**TOWN OF NEWBURGH  
PLANNING BOARD**

**PROJECT NAME:** MID VALLEY / STARBUCKS  
**PROJECT NO.:** 23-14  
**PROJECT LOCATION:** SECTION 75, BLOCK 1, LOT 13.1  
**REVIEW DATE:** 14 JULY 2023  
**MEETING DATE:** 20 JULY 2023  
**PROJECT REPRESENTATIVE:** KIMBERLY HORN ENGINEERING AND LANDSCAPE ARCHITECTURE

**SITE SKETCH**  
39 NORTH PLANK ROAD  
NEWBURGH, NEW YORK

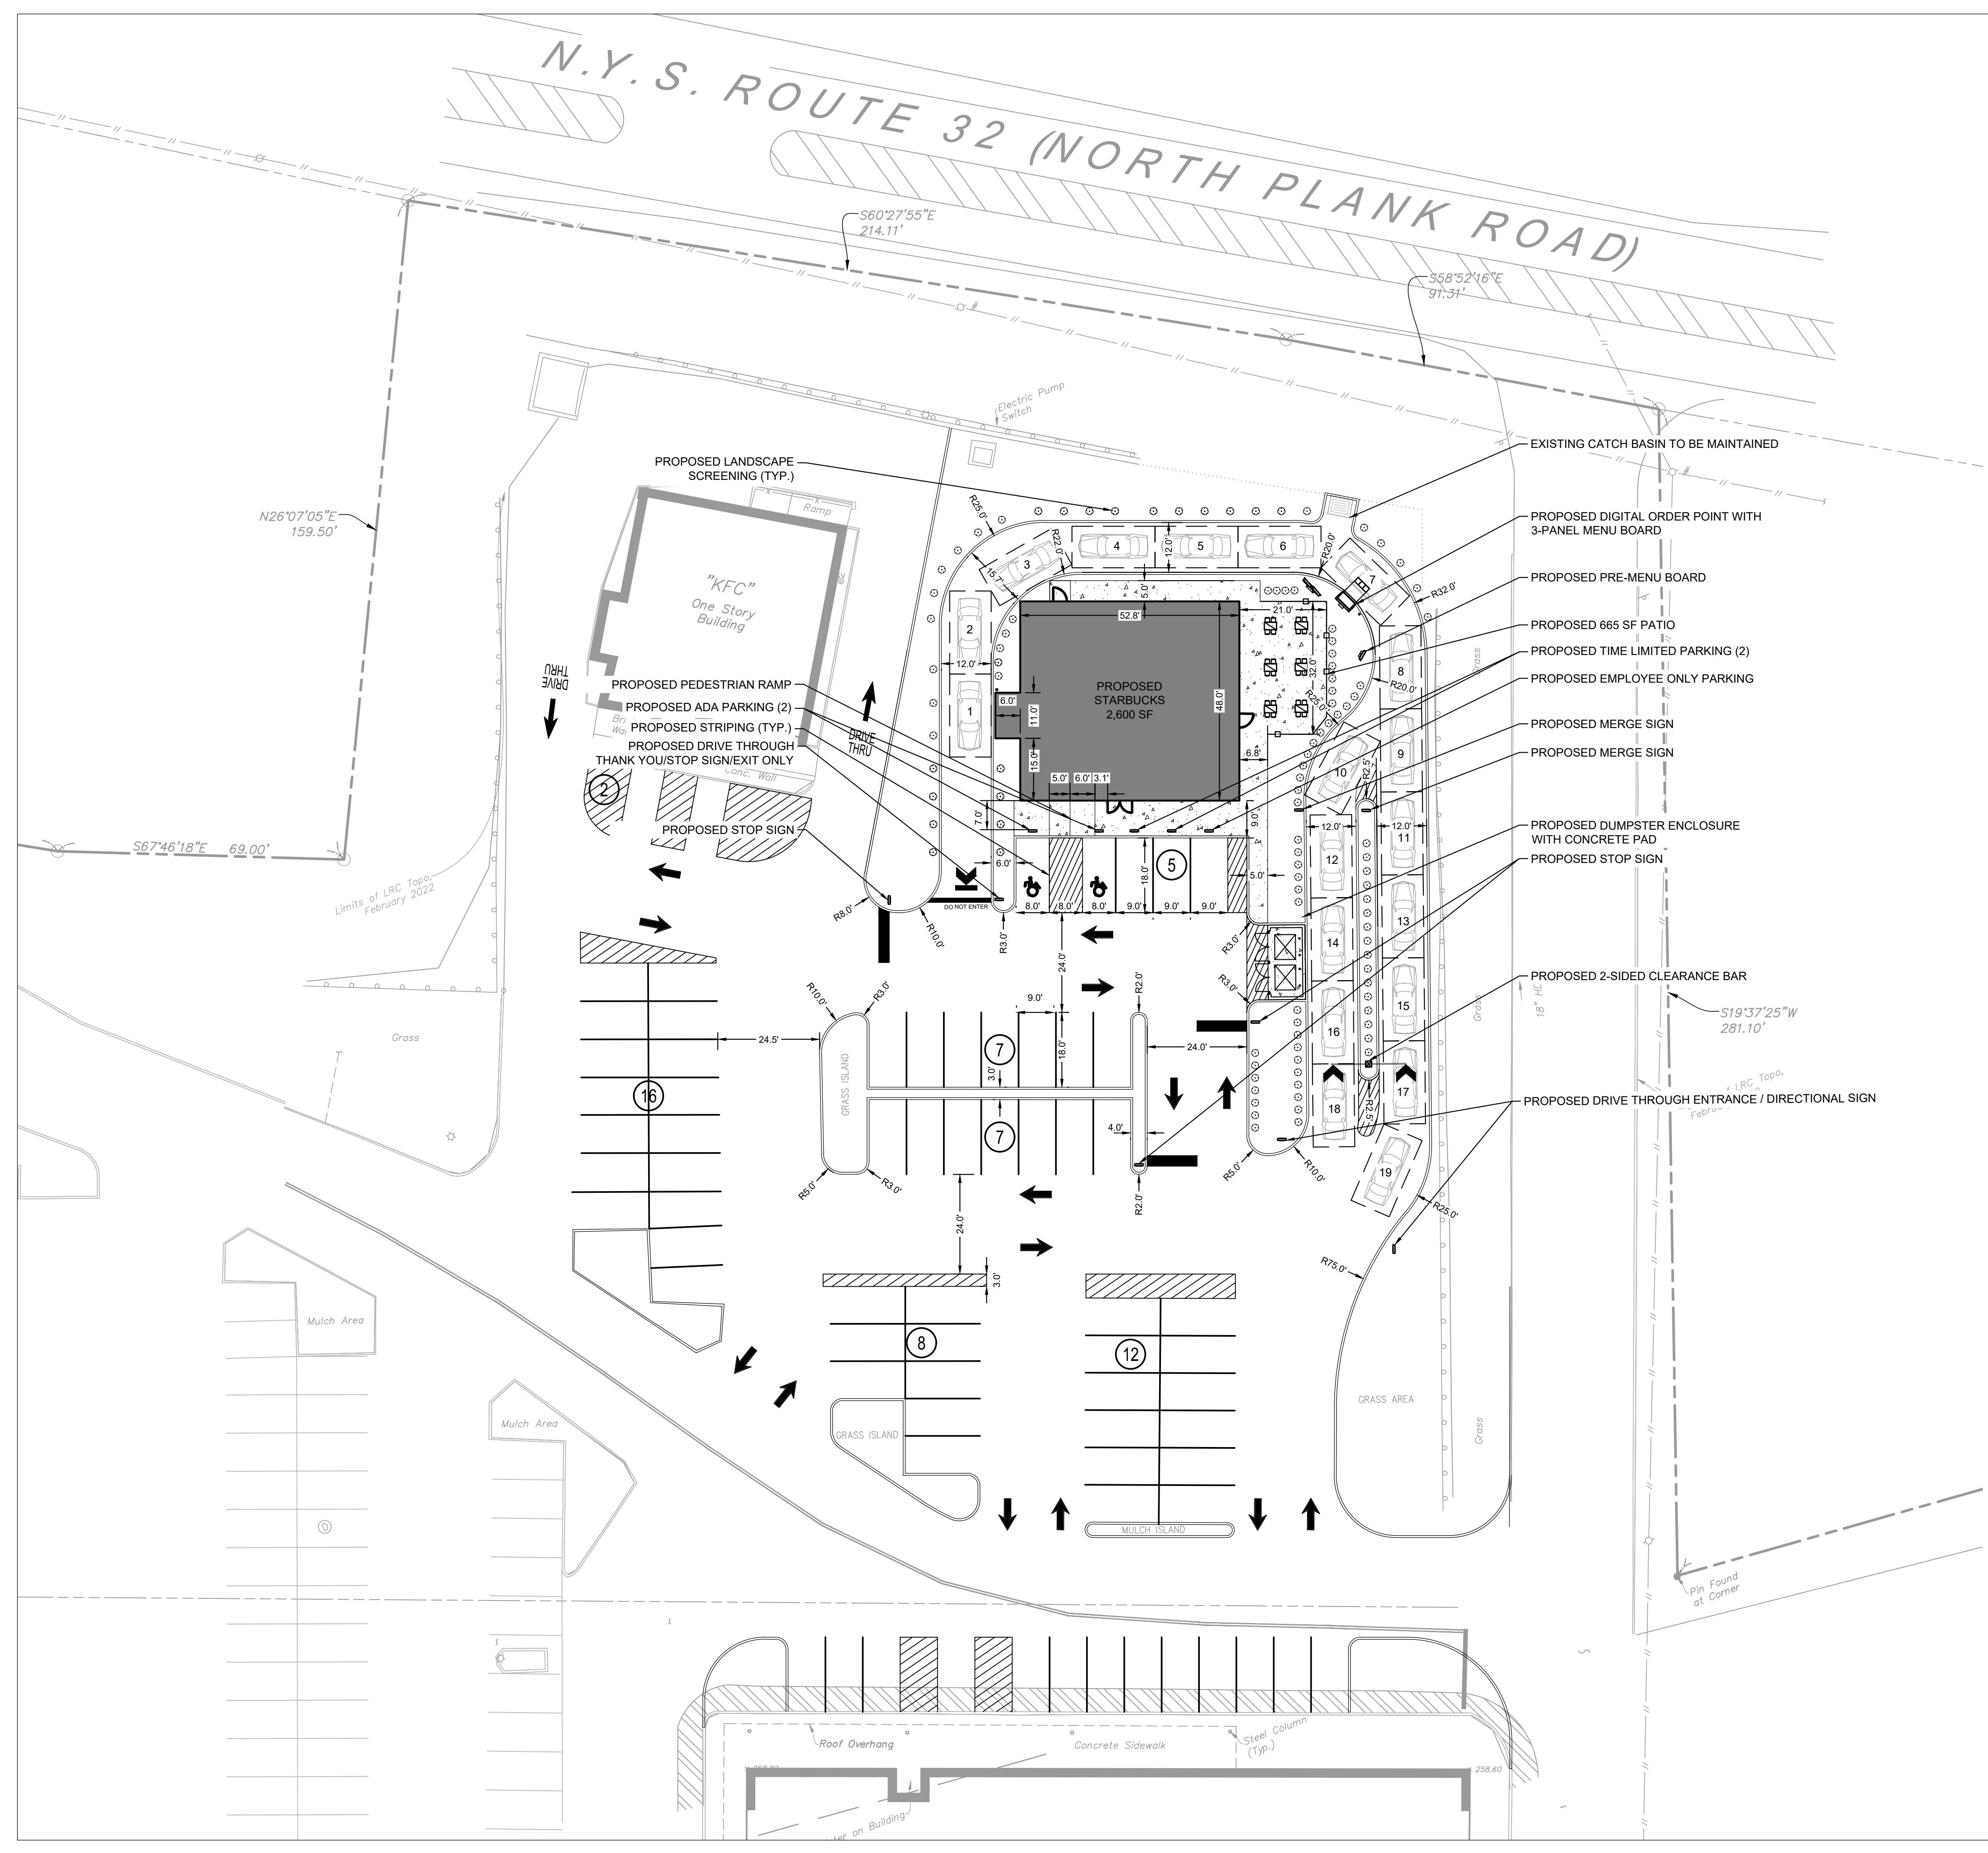
1. The proposed project results in a significant reduction of parking existing on the site. Approximately 60 parking spaces will be lost by the Site Plan. The project site is a “Unified Site Plan” with the entire Price Chopper/ Mid Valley Mall parcel. A parking calculation for the entire site must be prepared to identify adequate parking exists.

3. The queing aisles for the drive-thru do not have an “escape” area. Subjects queing into the drive-up window cannot leave the drive-up window area.
4. An accounting of impervious surfaces existing and proposed on the total project site should be identified.

8. The parking calculation for the site should be provided for the site based on the number of seats.
9. The Code Enforcement Department should address the fast food with drive-up window in the B Zoning District.

10. The plans should address the condition of the existing parking lot and modification to the stripping. Is the parking lot proposed to be overlaid with new asphalt pavement throughout?

11. A Grading Plan should be provided with future plans to evaluate the location of the structure with regard to the grades down to NYS Route 32.
